AMSON-NASSAR SPEC BUILDING, JSP 18-48

Public hearing of the request of Amson-Nassar Development for Preliminary Site Plan, Woodland Permit, and Storm Water Management Plan approval for a new 90,000 square foot Warehouse/Office building. The subject property contains 10 acres and is located in Section 16, south of Twelve Mile Road and east of West Park Drive, in the OST, Office Service Technology District.

PLANNING REVIEW

Revised Preliminary Site Plan

PROJECT: LAYOUT & PAVING PLAN

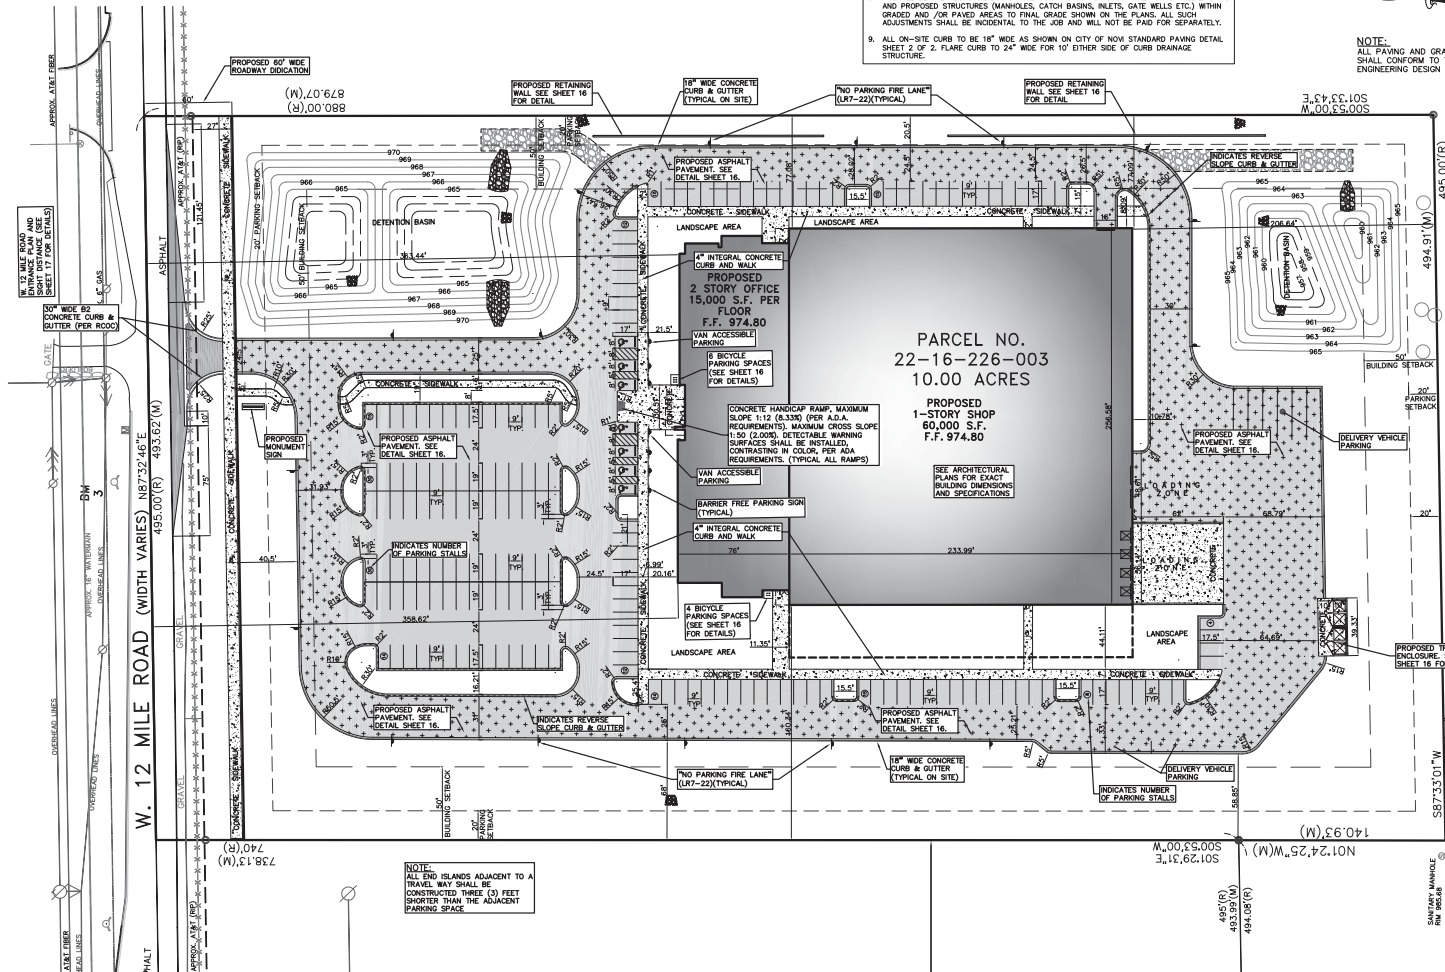
1. Revise the proposed building square-footage note on sheet 8 to the correct value.
2. Provide a bypass/passing lane on Twelve Mile Road to service to the development and to minimize backups on the north side of Twelve Mile Road. Coordinate road work with Oakland County.

3. Provide data in the utility crossing table on sheet 8 indicating that at least 18-inch vertical clearance will be provided; or that additional bedding measures will be utilized at points of conflict where adequate clearance cannot be maintained.

- ii. The applicant has indicated two (2) spaces are designated as van accessible and provided dimensions.
 - iii. The detail of the barrier free parking spaces on sheet 15 does not match the dimensions on sheet 5 for the barrier free spaces. The applicant should ensure the dimensions match.

- Dumpster Enclosure: The dumpster enclosure detail will be provided as part of the final site plan submittal package.
- Economic Impact:
- Parking Space Dimensions and Maneuvering Lanes: The grading plan has been revised to reflect the 4" high curb at the head of all 17' parking spaces. See sheet 6.

- End Islands: Dimensions have been added to all end islands. See sheet 5.
- Barrier Free Space Dimensions: The barrier free parking spaces have been revised and dimensioned. See sheet 5.

SITE PLAN REVISIONS 4-25-2019

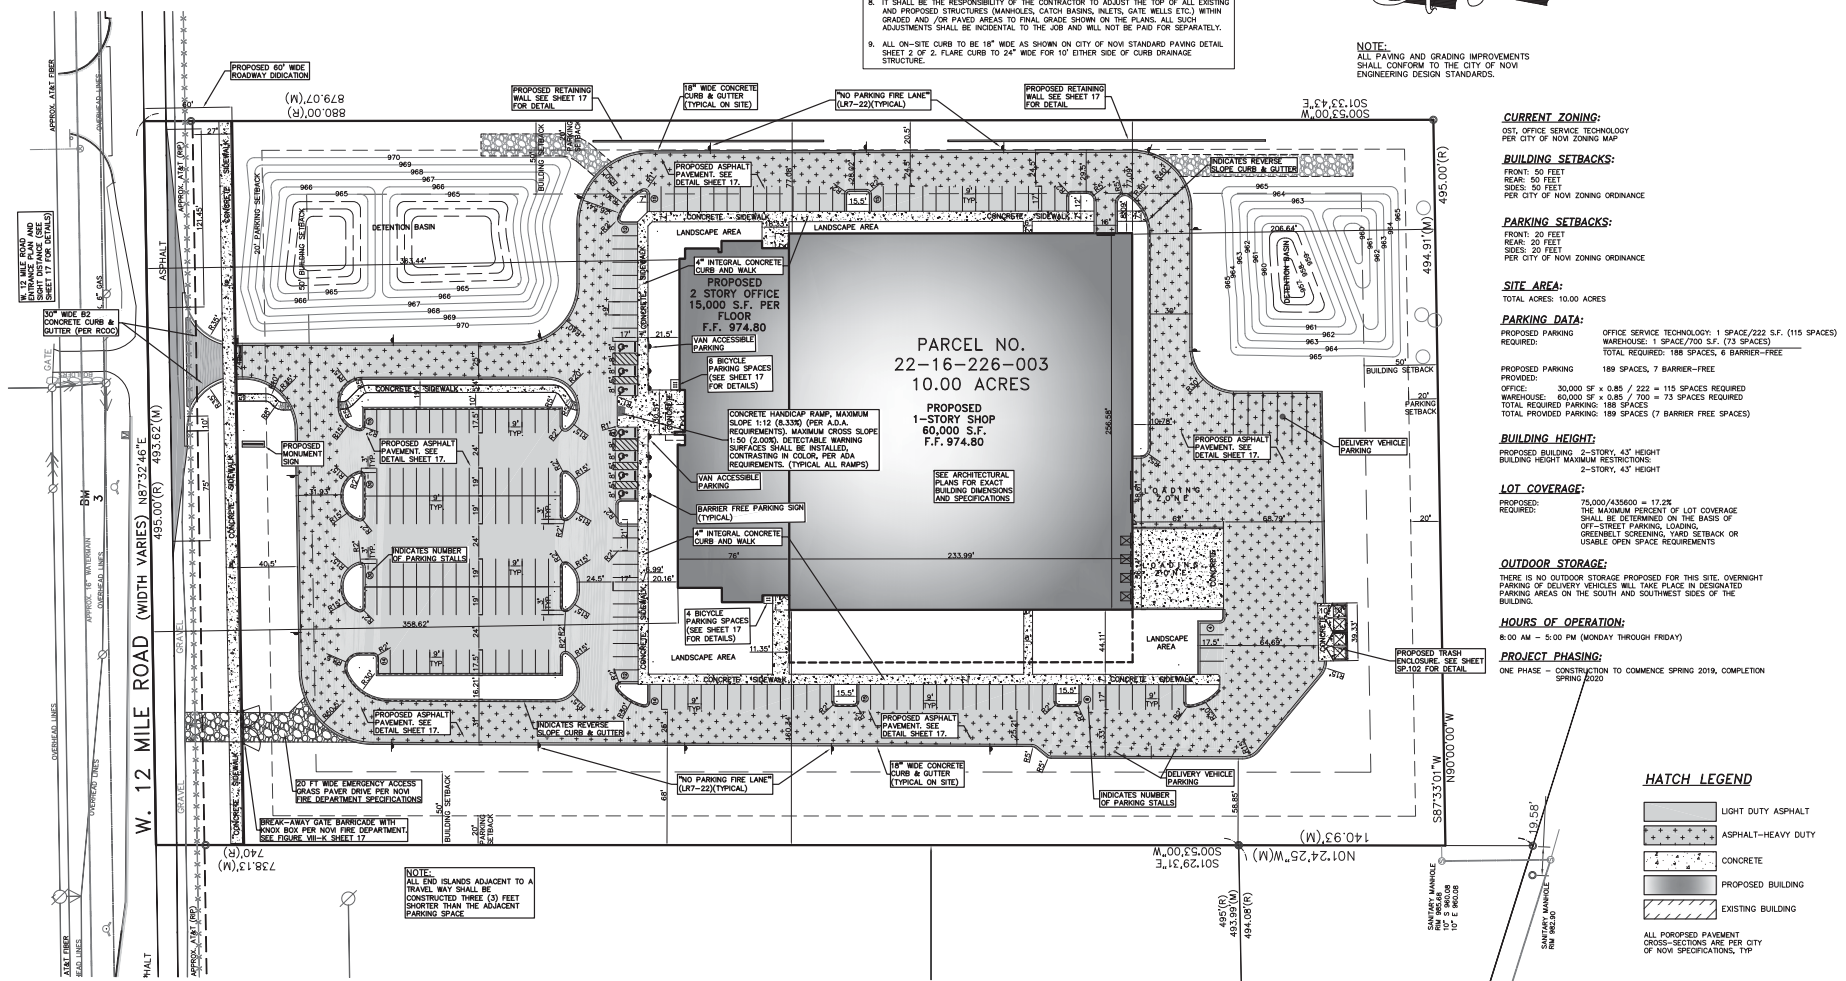
Fire	Approval not recommended	3-29-19	<ul style="list-style-type: none">• Secondary emergency access drive required (Applicant submitted revised layout 4-25-19 that shows secondary emergency access drive added)• Items to be addressed by the applicant prior to Final Site Plan approval
------	---------------------------------	---------	--

SOUTH ELEVATION
SCALE: 1/16"=1'-0"

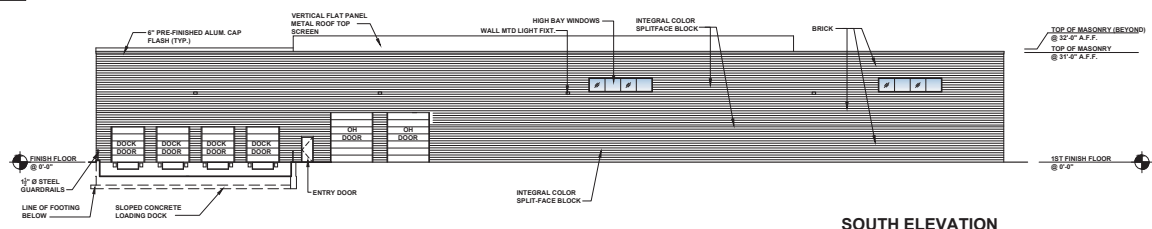
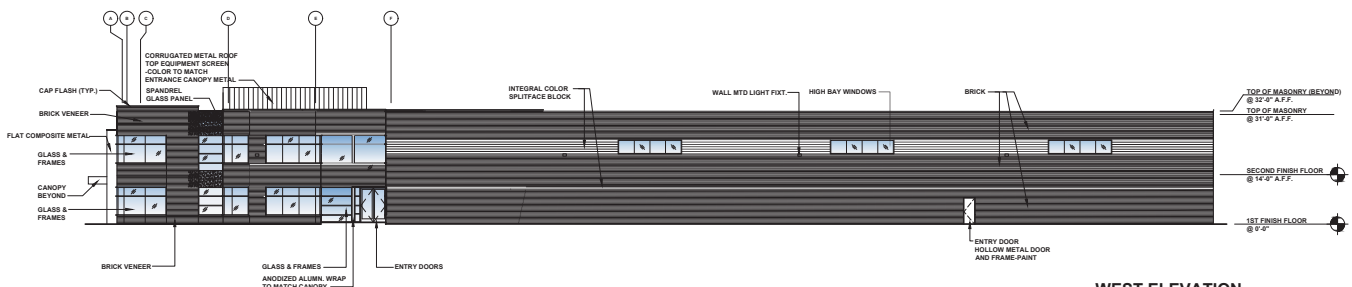
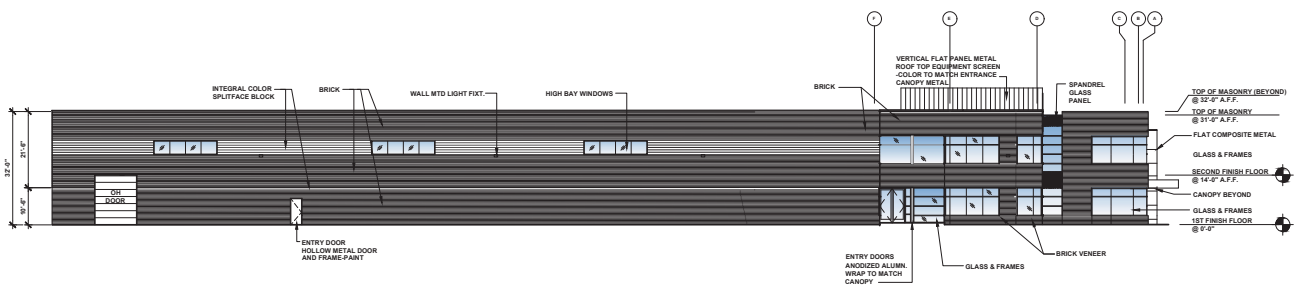
Façade	Approval recommended	5-3-19 (rev)	<ul style="list-style-type: none"> Applicant submitted revised building elevations to show changes that will be reflected in the Final Site Plan submittal (South elevation to be revised to reflect material chart) The proposed building is not compliance with the façade ordinance.

Recommendation - The applicant has revised the design in response to the review comments offered in our letter dated 4/14/19. All façade materials are now in full compliance with the Façade Ordinance. The discrepancies on sheet A.201 between the façade material percentage chart and the drawing notes and graphic patterns should be corrected. A sample board as required by Section 5.15.4.D of the Ordinance should be provided not less than 5 days prior to the Planning Commission meeting.

1. Refer to the revised Elevation sheet A-201 for the revised elevation materials and charts to meet the city requirements as required.
